Intel[®] Celeron[®] Processor Specification Update

Document Number: 243748-046

The Intel[®] Celeron[®] processor may contain design defects or errors known as errata, which may cause the product to deviate from published specifications. Current characterized errata are documented in this Specification Update.

Figure 1 Celeron® on 0.13 Micron Processor 256K Platforms Workaround

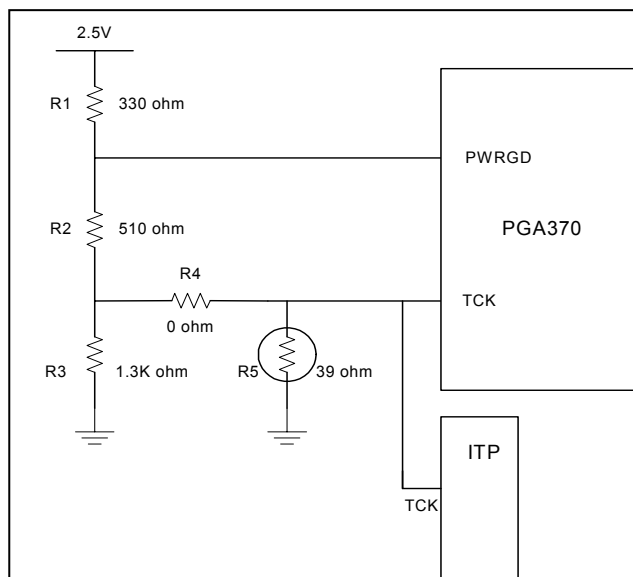
Workaround: To prevent the risk of power-on boot failures or catastrophic thermal failures, a platform workaround is required. The system must provide a rising edge on the TCK signal during the power-on sequence that meets all of the following requirements:

Please note, the example workaround circuits attached require circuit modification for ITP tools to function correctly. These modifications must remove the workaround circuitry from the platform and may cause systems to fail to boot. Review the accompanying notes with each workaround for ITP modification details. If the system fails to boot when using ITP, issuing the ITP 'Reset Target' command on failing systems will reset the system and provide a sufficient rising edge on the TCK pin to ensure proper system boot.

In addition, the example workaround circuits shown do not support production motherboard test methodologies that require the use of the processor JTAG/TAP port. Alternative workaround solutions must be found if such test capability is required.

For Production Boards:
Depopulate R5
